IDAP REPORT

34-36 Meredith Street Strathfield

DA2021/178

Demolition of existing structures and partial demolition, alterations and additions to the existing dwelling house and heritage item (I177) including demolition of rear portion, rear addition comprising a new first floor and basement level, construction of an in-ground swimming pool with spa, outdoor deck, cabana with bathroom, restoration and alteration of existing tennis court and associated driveway and landscaping works.

Figure 16: Isometric Street Elevation Plan (South West)

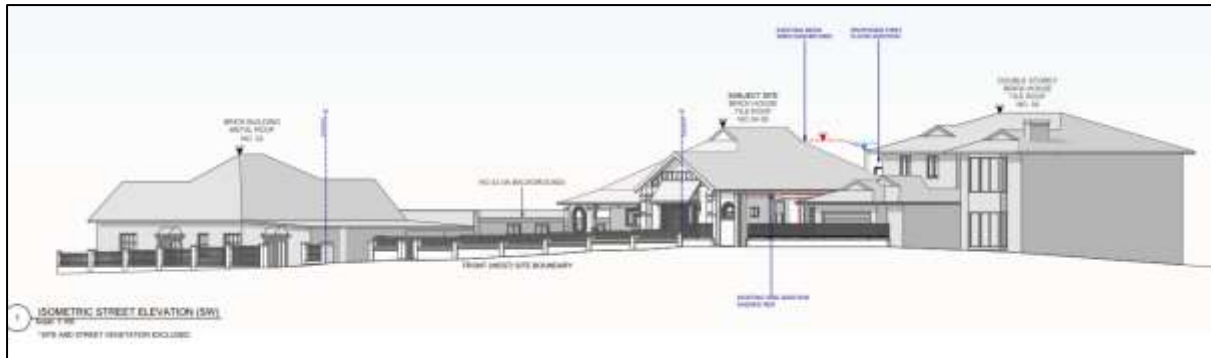
The application was referred to Council's Heritage Advisor for assessment. The following additional information was requested:

- *Photomontage from the public domain without vegetation. The current two dimensional image does not show the depth and the impact of the materials on the heritage item.*
- *Structural report for the heritage item and any adjoining development that may be affected in accordance with Section 2 Part P – Heritage – settings part (iv). This should examine mitigation measures to protect the heritage item from the impact of excavation which appears close to the original footings?*
- *A plan that indicates the 1980 addition and any proposed changes to the original dwelling.*

Amended plans were submitted during the assessment of the application by way of photomontages, isometric street elevations and structural plans. The submitted isometric street elevation plans below demonstrate that the rear additions have been appropriately scaled and located on the site so as to ensure that the new addition remain as a recessive feature of the dwelling when viewed from the public domain. It is noted that (whilst not shown in the submitted isometric elevation plans) the mature street tree planting as well as planting in the front yards of the site and adjoining properties will further reduce the appearance of the rear addition.

Comments: Additional information by way of isometric street elevation plans were submitted during the assessment process. The plans demonstrate that the proposed rear addition will not be readily visible from various angles from the street and that the original single storey front portion of the dwelling will still be able to be interpreted as such. The scale and massing has been carefully considered to ensure that the new rear additions will be hidden from view where possible and do not detract from the appearance of the heritage item as viewed from the street. The proposed landscaping scheme is considered appropriate and will further assist in softening the built form.
